**AGENDA
PLANNING COMMISSION
CITY OF WYOMING, MINNESOTA
JULY 28, 2026
7:00 PM**

TO:	Planning Commission
DATE:	July 28, 2026
FROM:	Kim Lindquist, City Planner Fred Weck, Zoning Administrator
RE:	Site Plan Review
APPLICANT:	Emily Nepp, ISG for the property owner Rosenbauer Minnesota, LLC
PROPERTY:	5181 260th Street, R.21.00468.33
FILE NO.:	SP-26-002 & V-26-001

TO:	Planning Commission
DATE:	July 28, 2026
FROM:	Kim Lindquist, City Planner
	Fred Weck, Zoning Administrator
RE:	Site Plan Review & Variance Request
APPLICANT:	Robb Linwood, for the property owner
	City of Wyoming
PROPERTY:	26885 Forest Boulevard, R.2100171.00
FILE NO.:	SP-26-003 & V-26-002

SITE PLAN

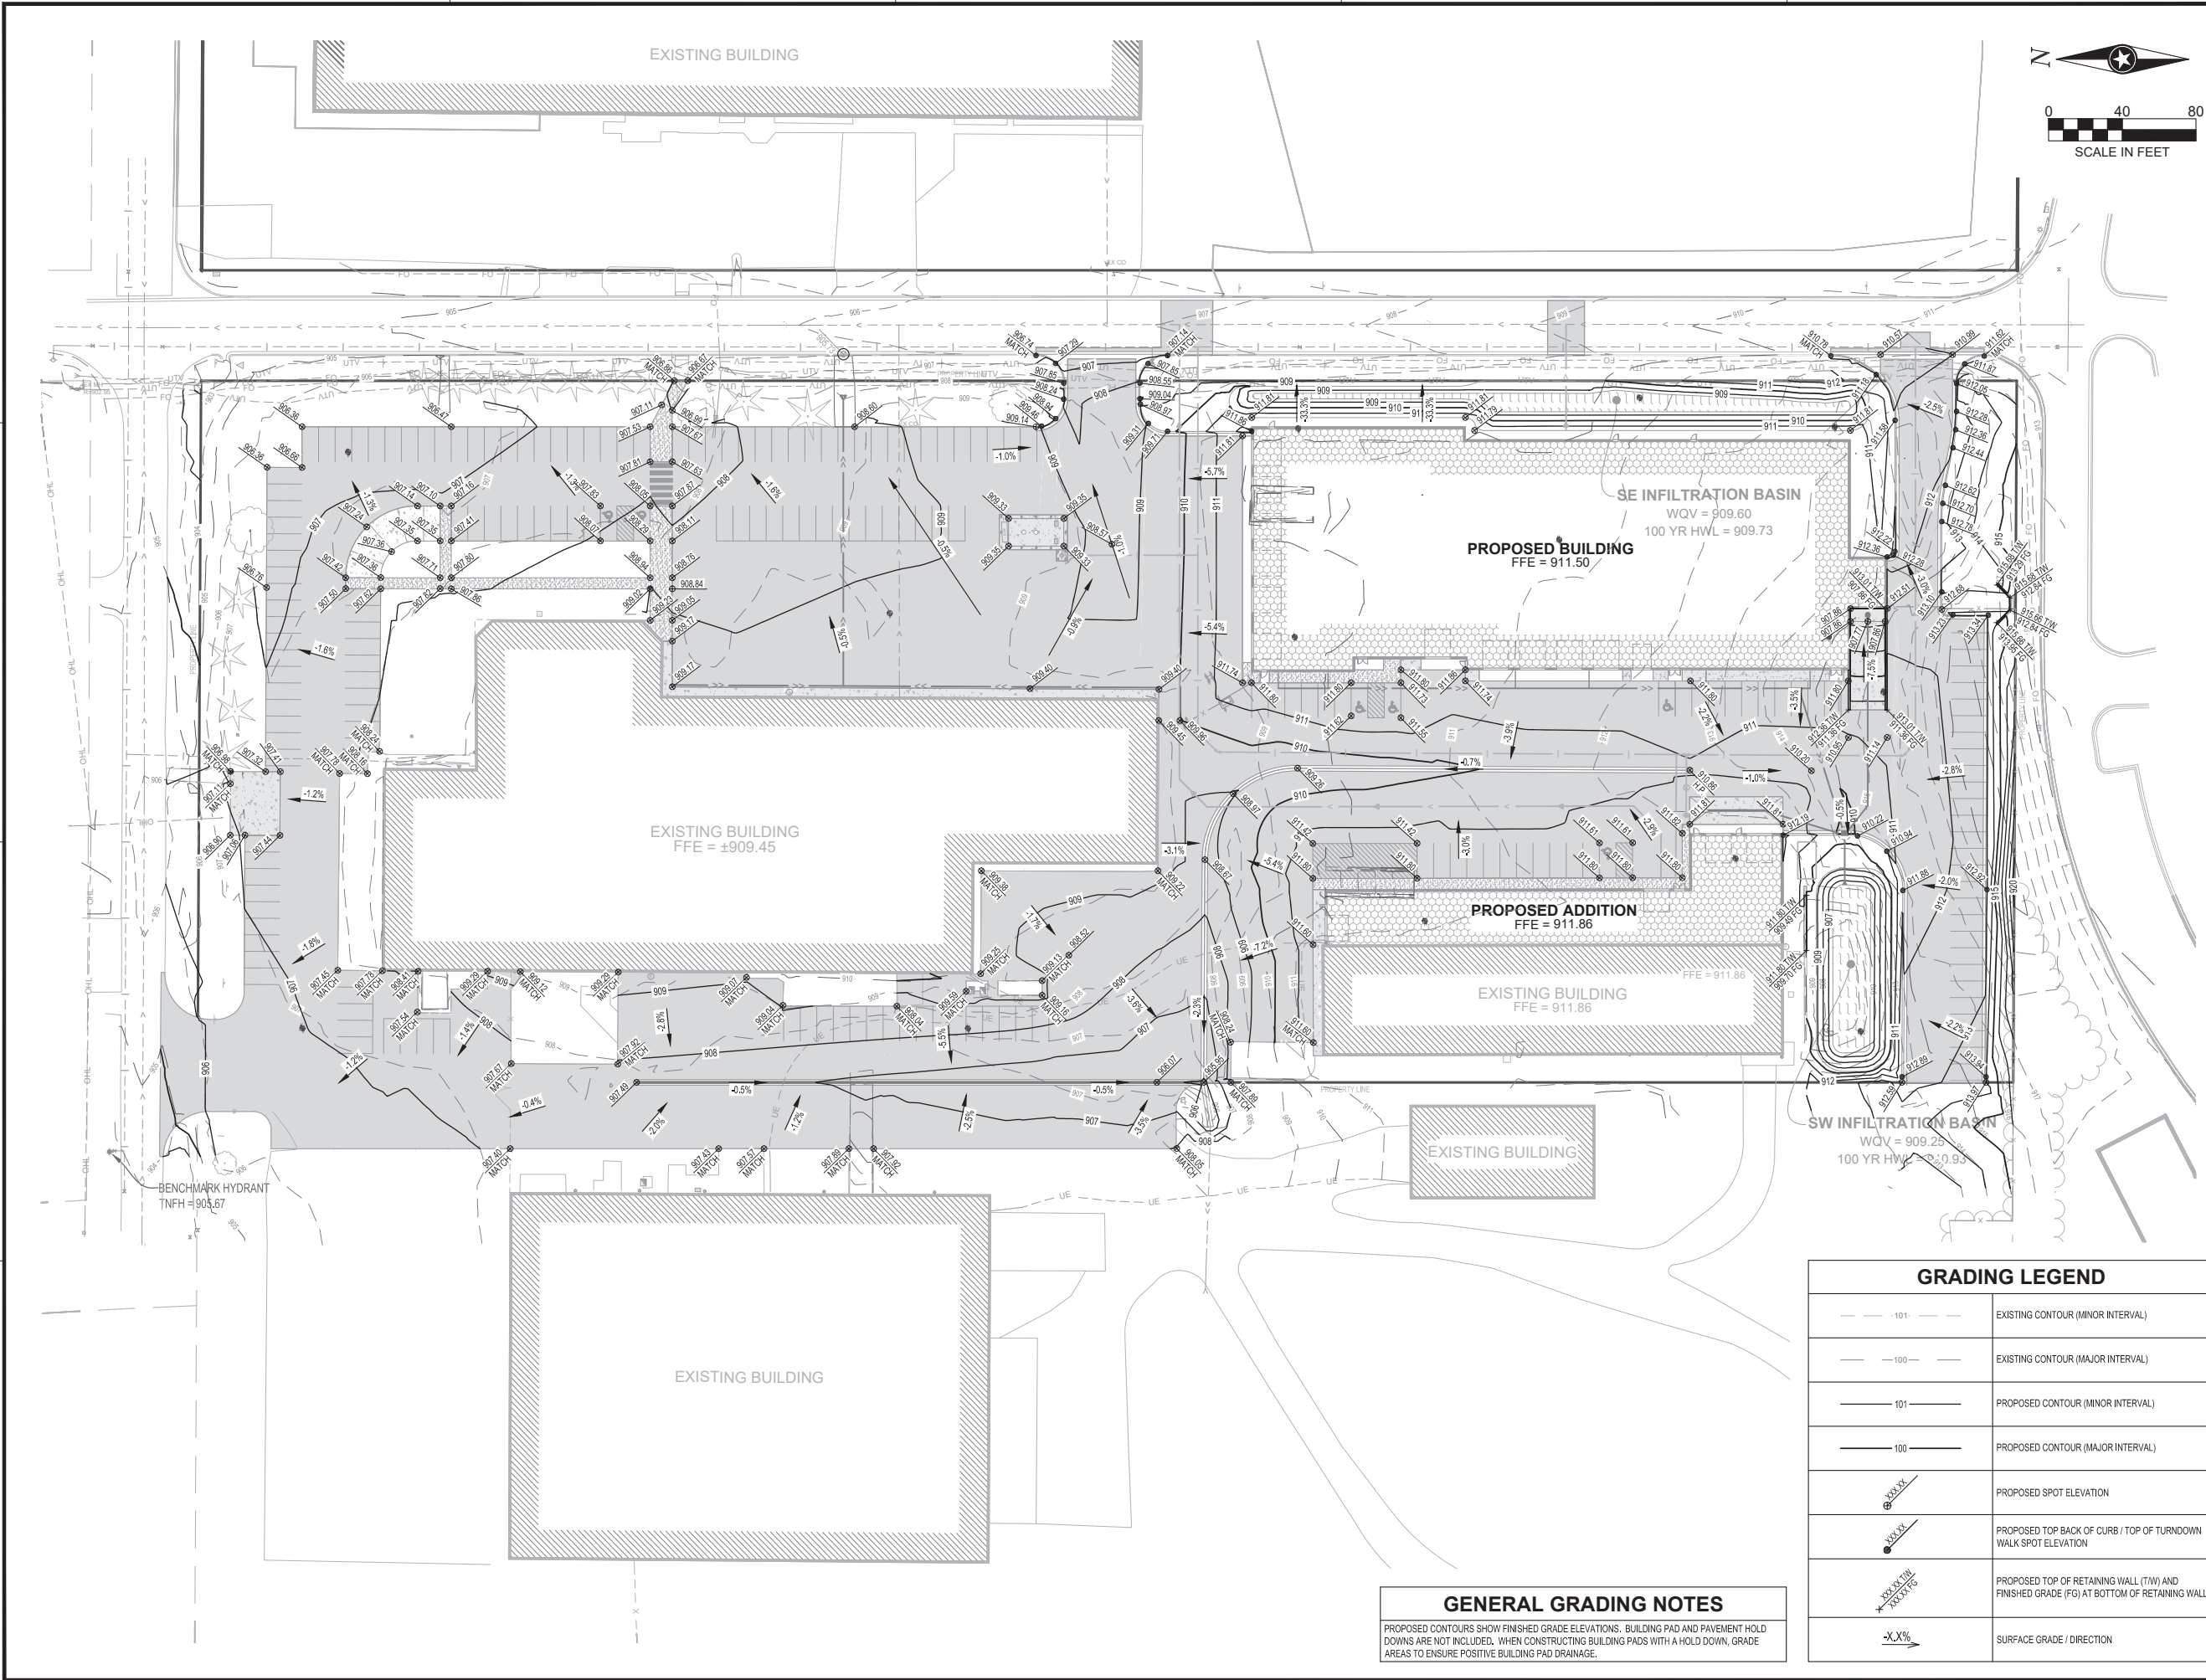
The applicant proposes bituminous pavement at the south end of the site to replace the existing Class V surface, as well as mill-and-overlay repairs to the existing parking area. The total parking area will be striped for 216 stalls, including 6 accessible stalls. Manufacturing uses require 1 space for each employee on the major shift or 1 space for each 400 square feet whichever is greater. The applicant has indicated that 205 parking spaces would be required, based on the shift employee numbers.

6. The applicant shall submit a new site plan which depicts the southeast parking area in compliance with the 15’ parking lot setback requirement.
7. The applicant shall submit an updated stormwater plan based on the staff report, including the amount of new and fully reconstructed impervious surfaces for the site, designating emergency overflow locations and ensuring that the lowest floor elevations for Building 2 are 2’ above the EOF.

PLANTING PLAN

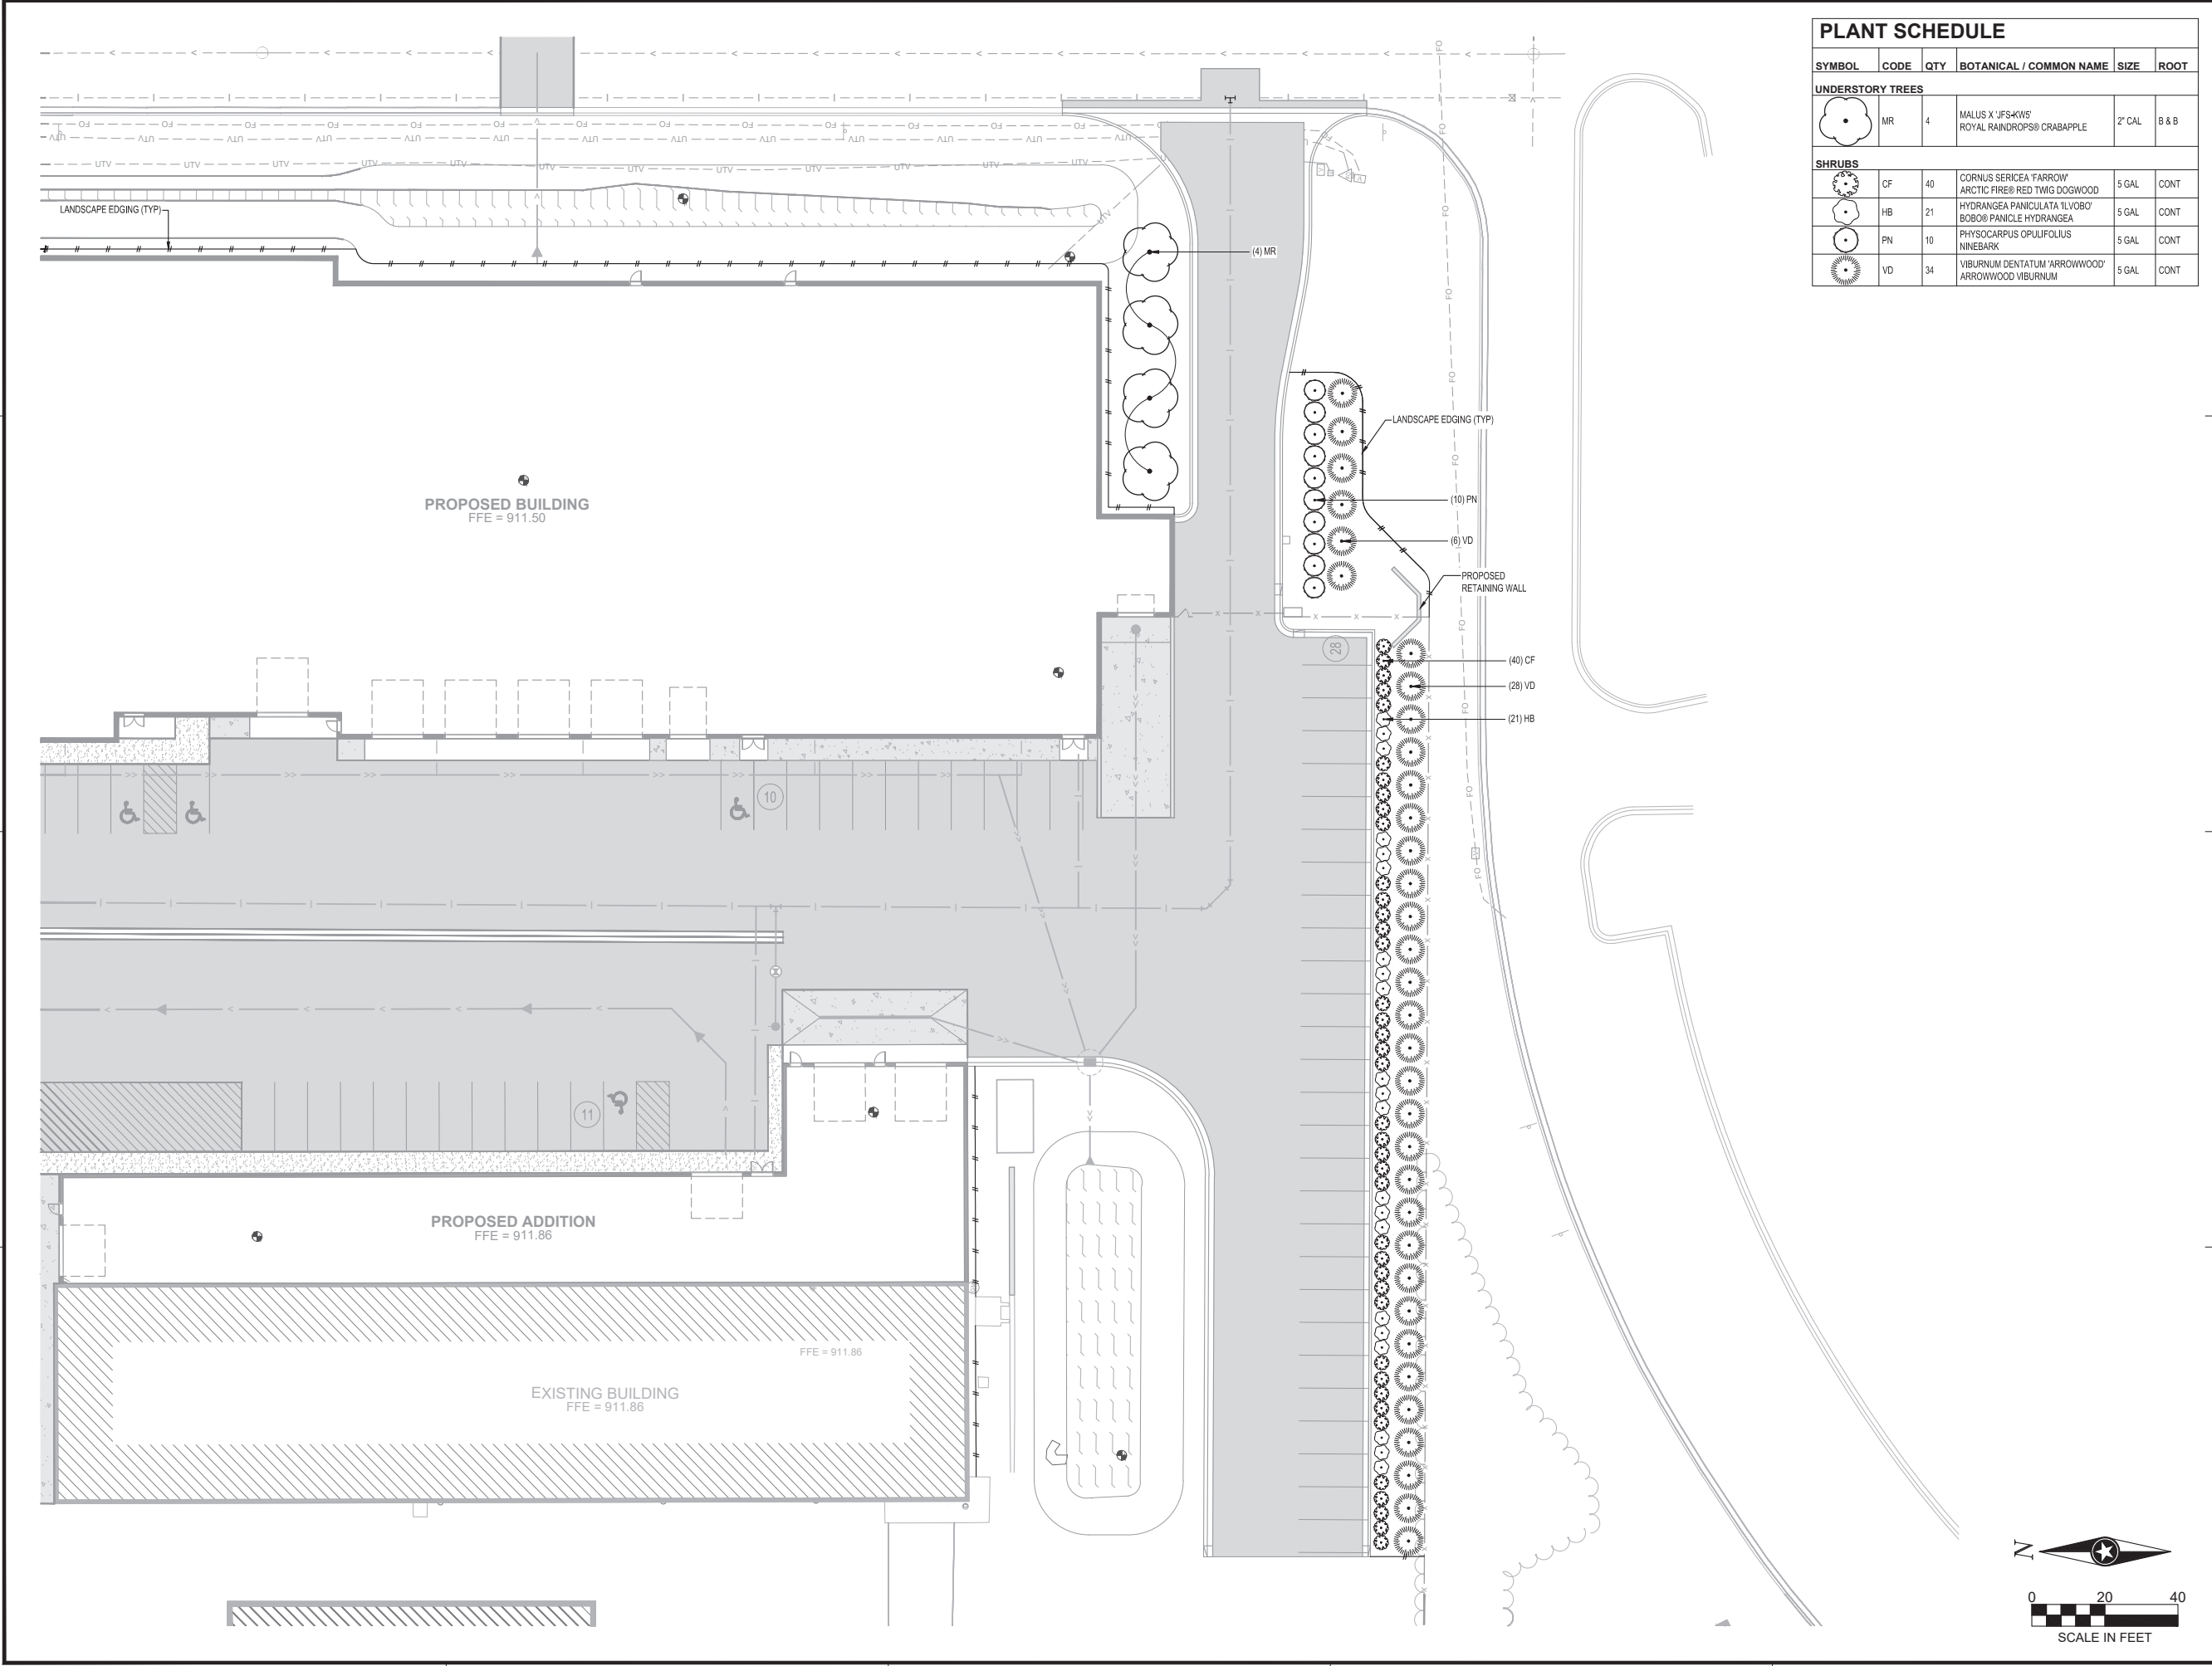
No new landscaping is proposed on the site. The applicant has requested a waiver for the landscaping requirements based on safety concerns. Further, the submitted plan shows the removal of 8 trees that would be replaced with turf, adjacent to the existing principal structure. It is unclear

why these internal trees would be considered a safety hazard. If so, lower profile plantings should be installed to compensate for the tree removal. This landscaping can be strategically placed to maintain the sightlines onto the property.

The applicant also cited the request for reduced screening along the southern property line due to the hospital's helicopter pad. Although initially intended to be close to the southern parcel border, the helicopter pad is not adjacent to the site. The applicant should install trees along the southern property line, in order to maintain consistency with the ordinance and provide a buffer between the two uses.

5. The applicant shall submit a landscape plan based on the staff report for staff review and approval, prior to issuance of a building permit. The landscaping plan should include landscaping to replace the removed trees around the preexisting building’s entrance and trees planted along the southern parcel border, adjacent to the hospital.

The applicant should submit a revised landscape plan for staff review and approval prior to issuance of a building permit.
